NINE MILE POINT
NUCLEAR STATION

SUBJECT: Nine Mile Point Nuclear Station
Unit No. 2; Docket No. 50-410

Response to Request for Additional Information Regarding Nine Mile Point Nuclear Station, Unit No. 2 – Re: Steam Dryer Review of the License Amendment Request for Extended Power Uprate Operation (TAC No. ME1476)

Figure 17.2 (from Reference 17.1)

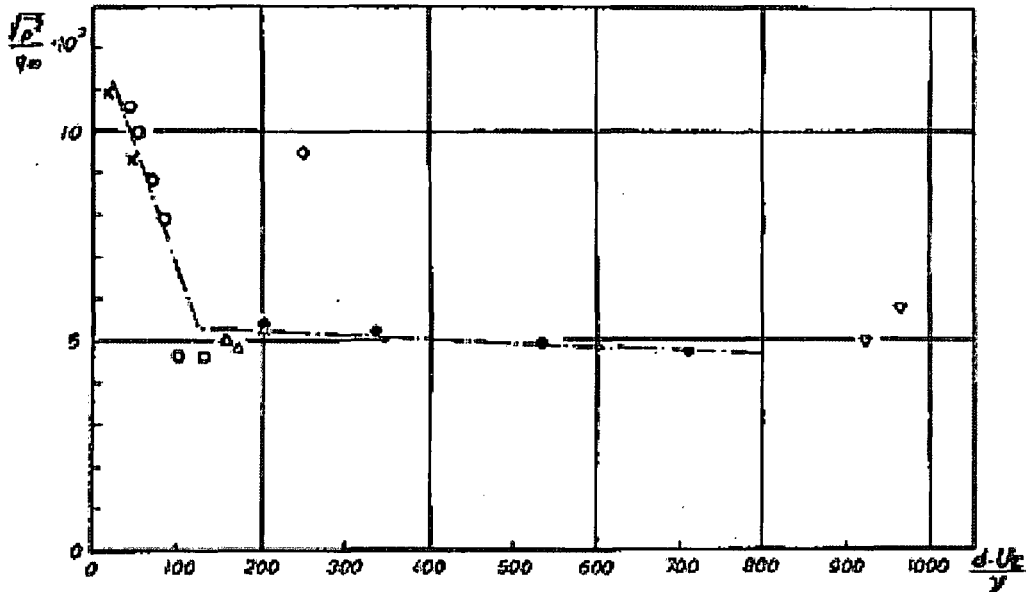
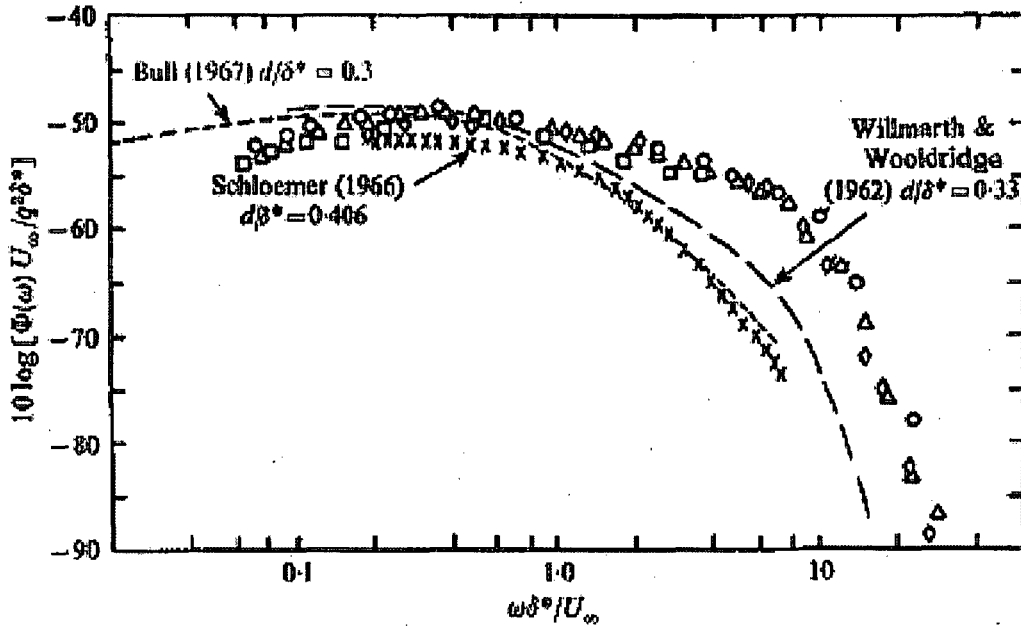
Fig. 9.1 of CDI Report No. 08-13P, Rev 1, "Flow-Induced Vibration in the Main Steam Lines at Nine Mile Point Unit 2 and Resulting Steam Dryer Loads," provides the bump-up factor which should be used to estimate the EPU loading from the measured CLTP loading. [[

The NMP2 steam dryer evaluation was performed in accordance with NRC approved BWRVIP-182. This guidance provides a flow chart to screen for acoustic resonance conditions. Provided the screening meets the margins required by BWRVIP-182, the application of velocity squared is justified and scale model testing or other methods such as MSIV closure testing to define the bump is factor are not required. The NMP2 performance of the CDI proprietary 1/8th scale testing is above the guidance and was performed as a conservative measure to confirm the conclusions of the BWRVIP-182 resonance screening calculations. The conclusions reached from the scale model testing remain that the appropriate scaling for NMP2 is velocity squared based on the average bump-up factor across the 0 to 250 Hz frequency band.

Figure 9.1 of CDI Report No. 08-13P Rev. 1 is reproduced here as Figure 17.1, with the mean value of the bump-up factor shown. Standpipe excitation is not predicted to occur until well above EPU conditions (at a Mach number of 0.160, compared to the EPU Mach number of 0.110). [[

Figure 19.1a: Weld Connecting Diagonal Gusset to Inner Base Plate (viewed from underneath the steam dryer)

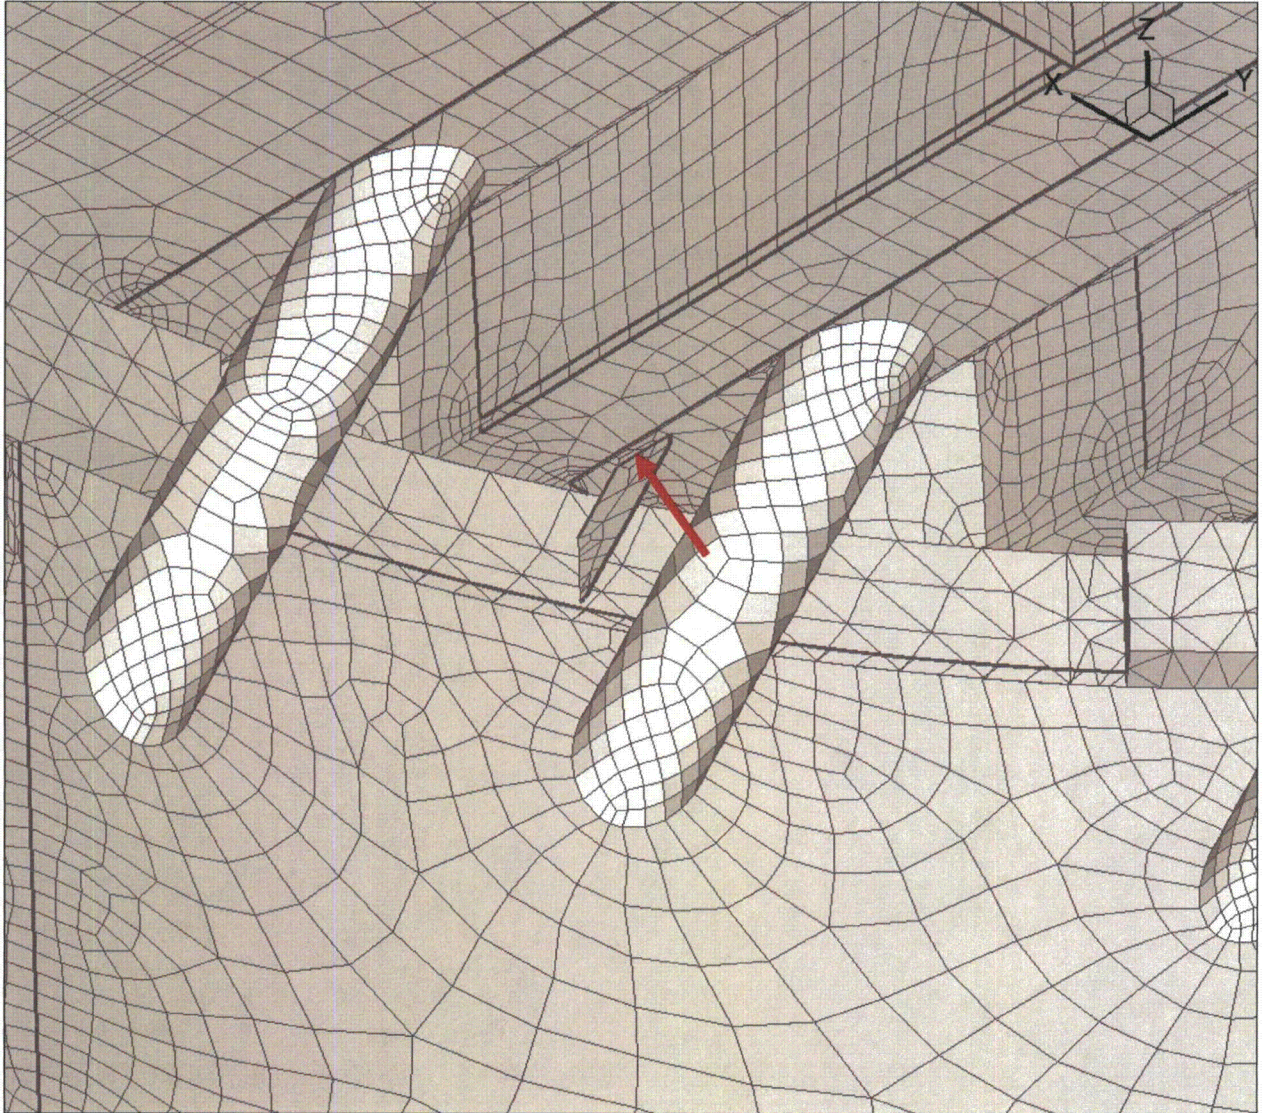
The licensee is requested to provide the size and locations of any undersized fillet welds in the NMP2 steam dryer, and explain how the fatigue stresses are calculated at those welds.

Two locations on the NMP2 steam dryer contain undersized welds. Table 19-1 lists these locations together with the component thicknesses and undersize weld factors (USWF). The locations are also depicted in Figure 19-1. Fatigue stresses at these locations are conservatively calculated by multiplying the alternating stress intensities (S_{alt}) by the square of the USWF before comparing to allowable stresses.

The usual weld factor (i.e., 1.8 for fillet welds) is also applied together with a factor of 1.1 to account for the temperature variation of the Young's modulus for stainless steel to obtain the final alternating stress ratio, SR-a. This approach is conservative since using the square of the USWF is only required for the bending stress components; for membrane stresses using the USWF (i.e., not the square of this quantity) is permissible. However, the approach is straightforward to implement computationally. The limiting alternating stresses and alternating stress ratios at these locations are also listed in Table 19-1 for CLTP operation using the current steam dryer configuration.

For both locations the alternating stress ratios are above 5.0 so that fatigue stresses in the weld are well below allowable levels.

Description	Part Thickness (in.)	Weld Size (in.)	USWF	S _{alt} (psi)	SR-a
Weld connecting inner base plate to diagonal gusset (see Figure 19-1a)	0.5	0.25	2.00	343	5.01
Weld joining lifting lug brace to collar (see Figure 19-1b)	0.375	0.25	1.50	532	5.74
